GENERAL ELECTRICAL SITE PLAN

11-5-93	REVISED SYMBOLS AND HWY. I.D. TAG NOTES AND ADDED NOTE 3 & NOTE 5
DATE	REVISION
STATE OF HAWAII DEPARTMENT OF TRANSPORTATION HIGHWAYS DIVISION	
GENERAL ELECTRICAL SITE PLAN	
INTERSTATE ROUTE H-3 F.A.I. PROJECT NO. I-H3-1(69) & (70)

SHEET No. E1 OF 28 SHEETS

ELECTRICAL SITE PLAN - PART I
SCALE = 1" = 40'-0"

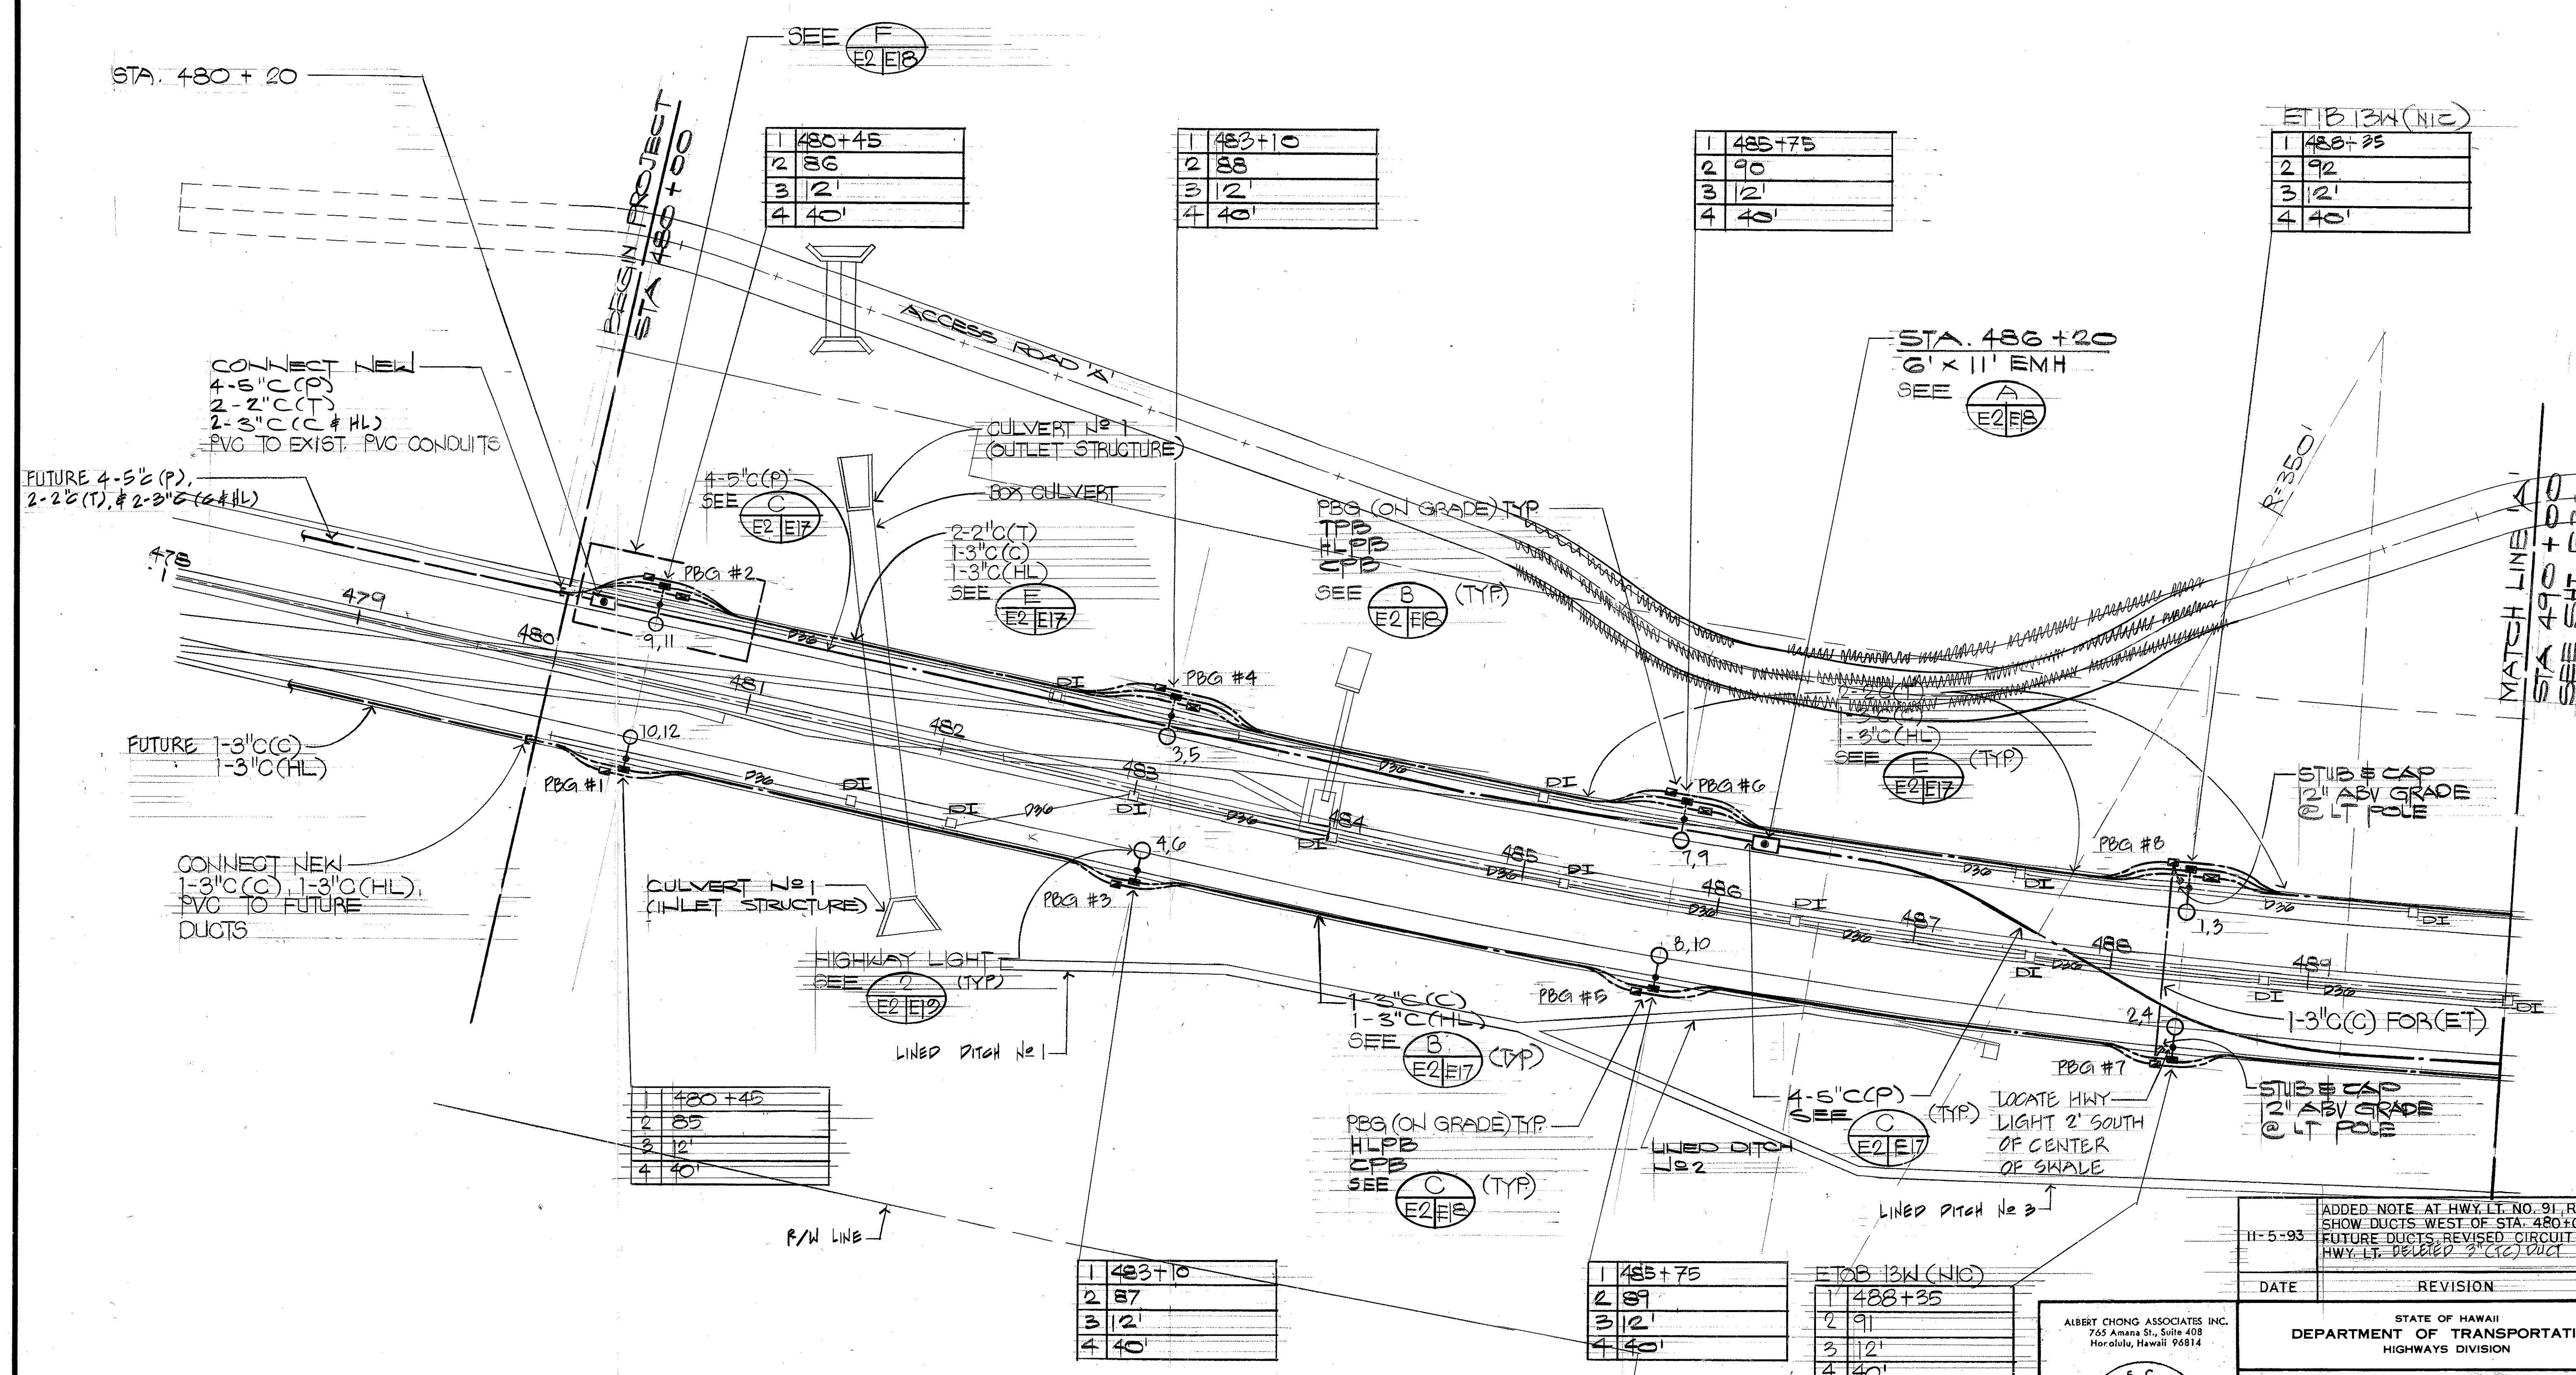
DATE	REVISION
11-5-93	ADDED NOTE AT HWY. LT. NO. 91, REVISED TO SHOW DUCTS WEST OF STA. 480+00. AS FUTURE DUCTS, REVISED CIRCUIT NO. FOR HWY. LT. DELETED 2" (C) and
STATE OF HAWAII DEPARTMENT OF TRANSPORTATION HIGHWAYS DIVISION	
ELECTRICAL SITE PLAN - PART I	
INTERSTATE ROUTE H-3 F.A.I. PROJECT NO. I-H3-1(69) & (70)	
SHEET No. E2 OF 28 SHEETS

ELECTRICAL SITE PLAN - PART V

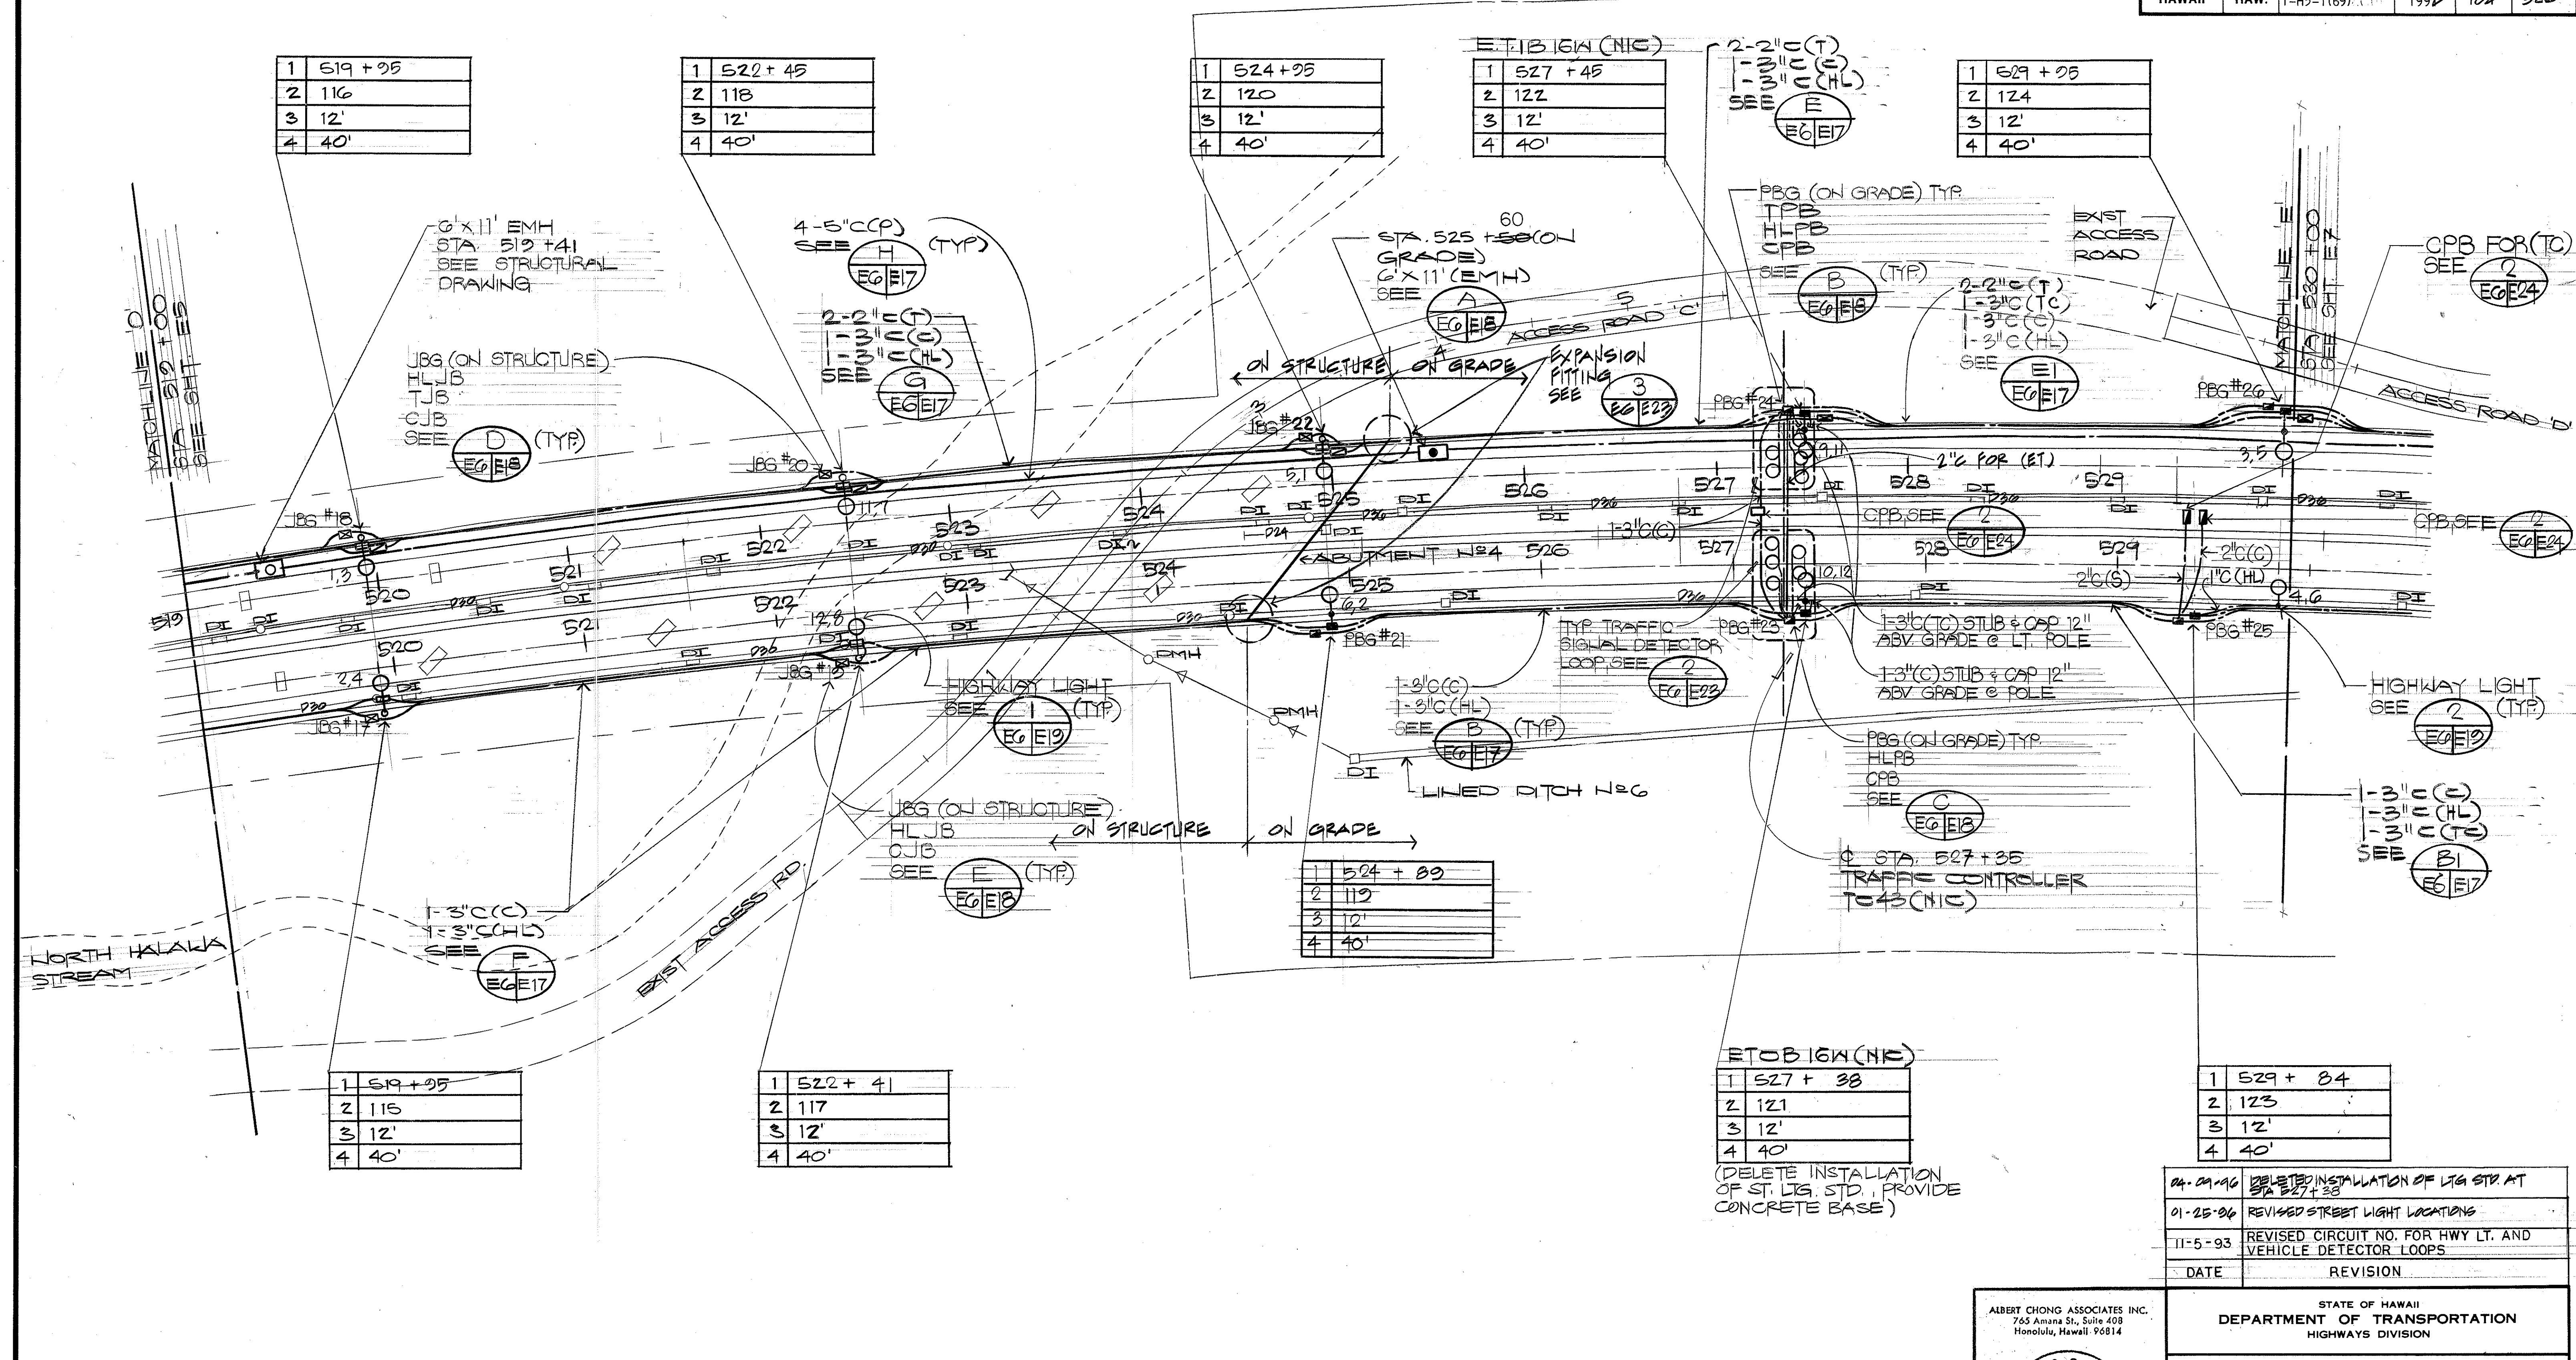
(DELETE INSTALLATION OF ST. LIG. STD. PROVIDE CONCRETE BASE)

DATE	REVISION
04-01-90	DELETED INSTALLATION OF LIG. STD. AT STA 527+38
01-25-94	REVISED STREET LIGHT LOCATIONS
11-5-93	REVISED CIRCUIT NO. FOR HWY LT. AND VEHICLE DETECTOR LOOPS

11.5KV POWER LINE AND 100 PAIR TELEPHONE LINE
 RELOCATION PLAN - PART I
 SCALE: 1" = 40'-0"

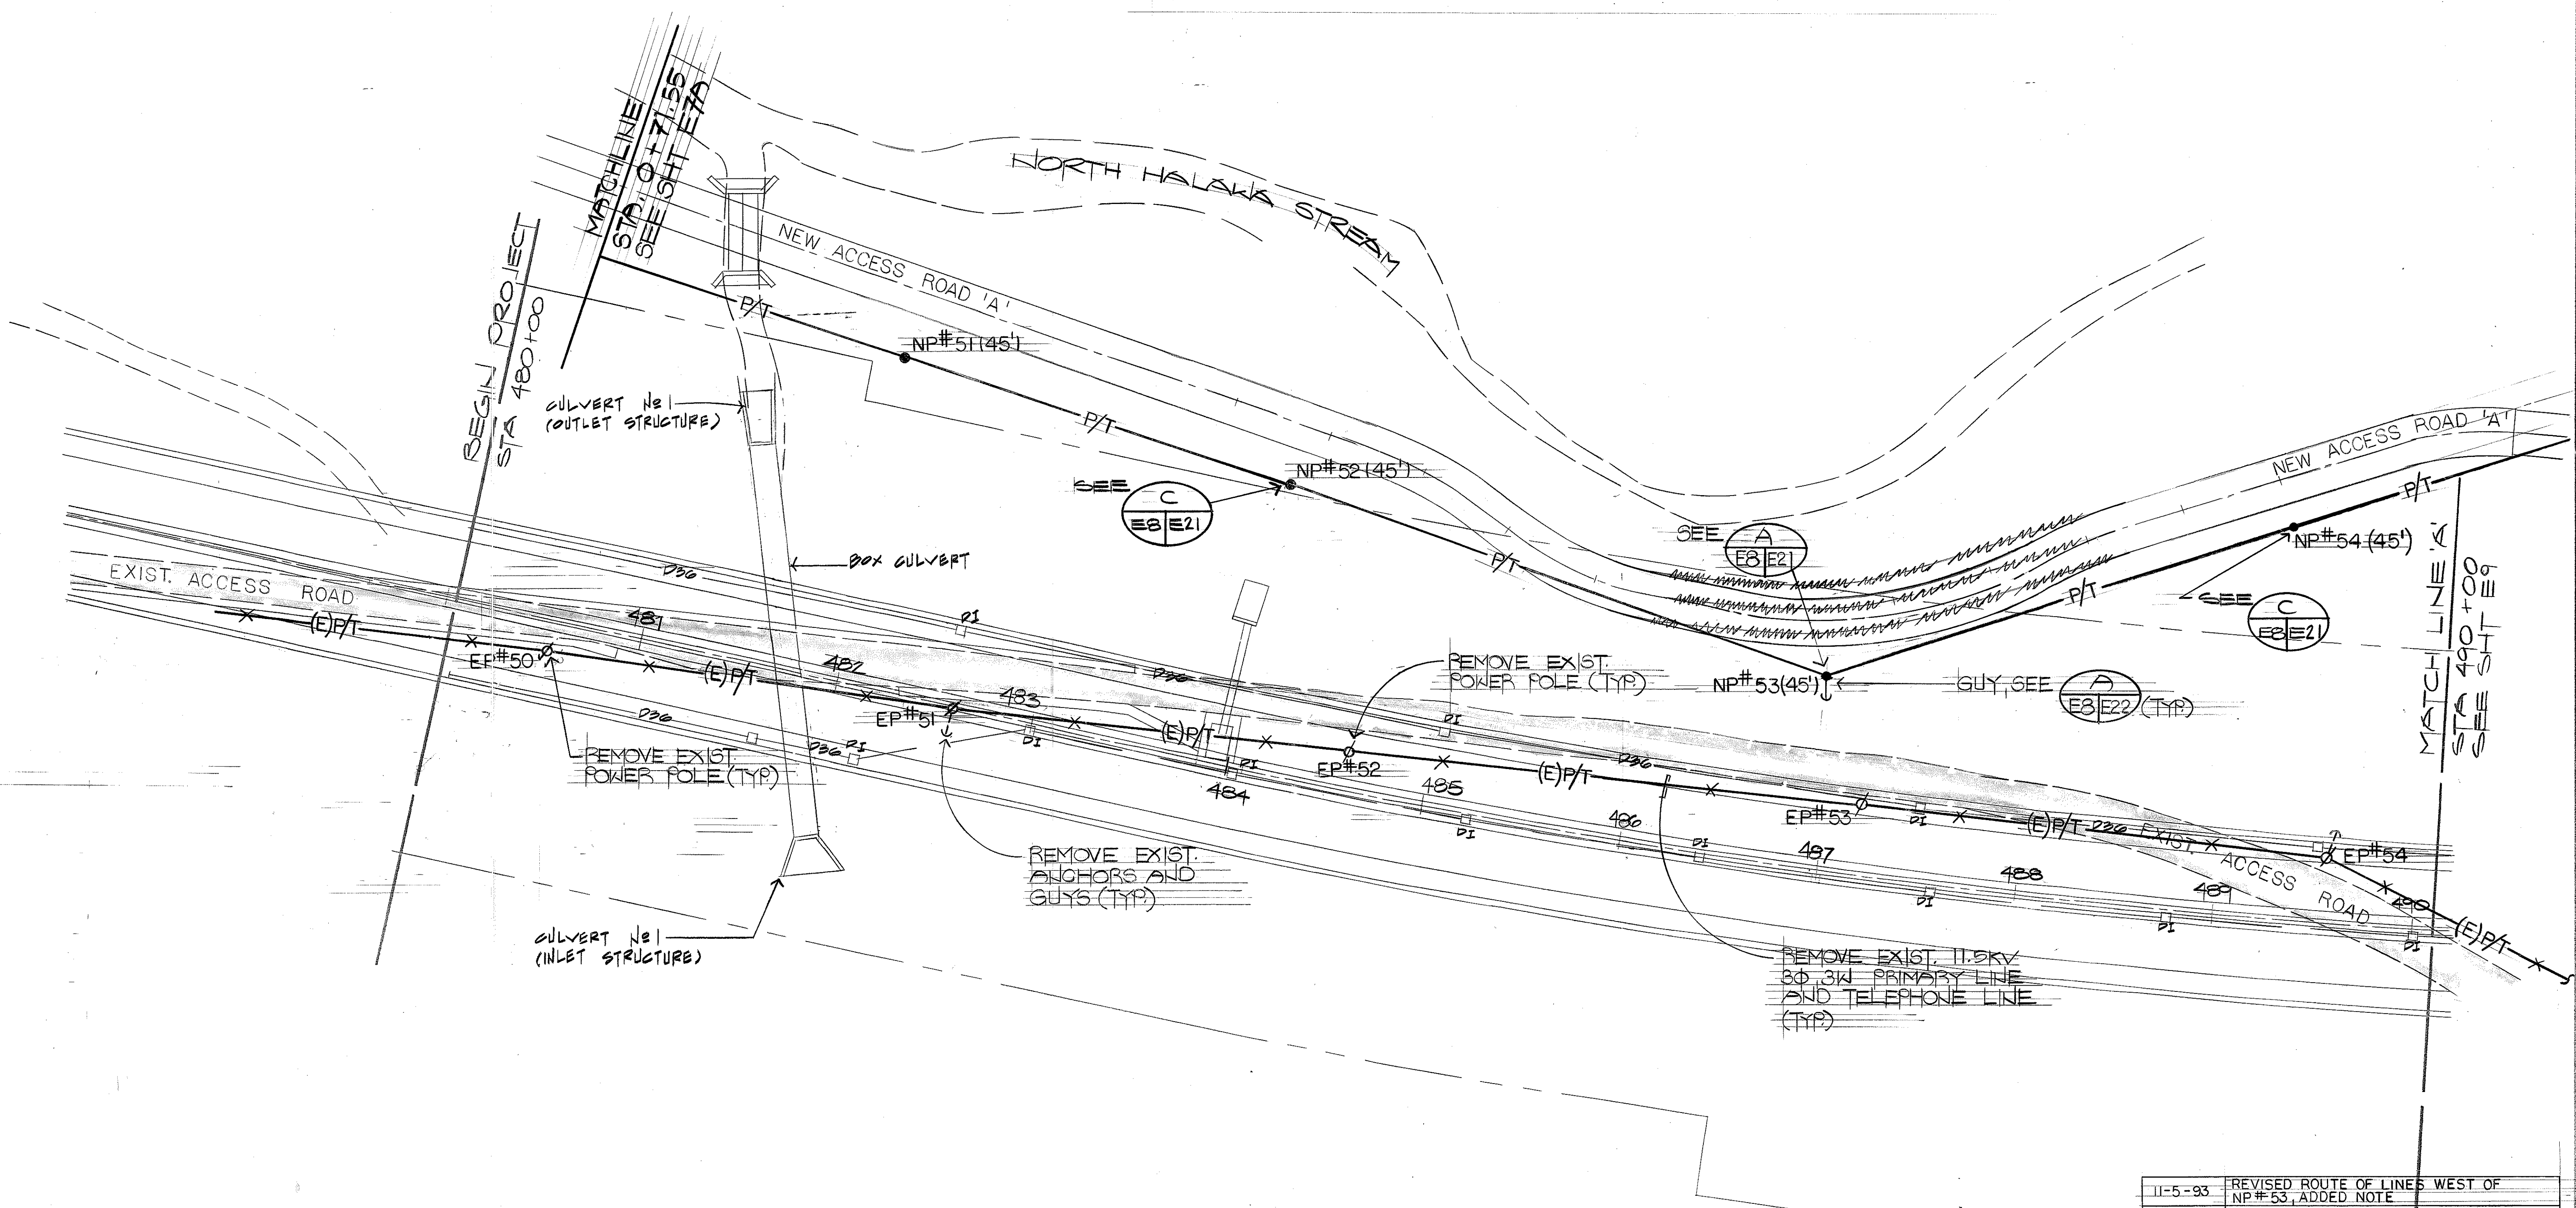
11-5-93	REVISED ROUTE OF LINES WEST OF NP#53, ADDED NOTE
DATE	REVISION
STATE OF HAWAII DEPARTMENT OF TRANSPORTATION HIGHWAYS DIVISION	
11.5KV POWER LINE AND 100 PAIR TEL. LINE RELOCATION PLAN - PART I	
INTERSTATE ROUTE H-3 F.A.I. PROJECT NO. 1-H3-1(69) & (70)	
SHEET No. E8 OF 28 SHEETS
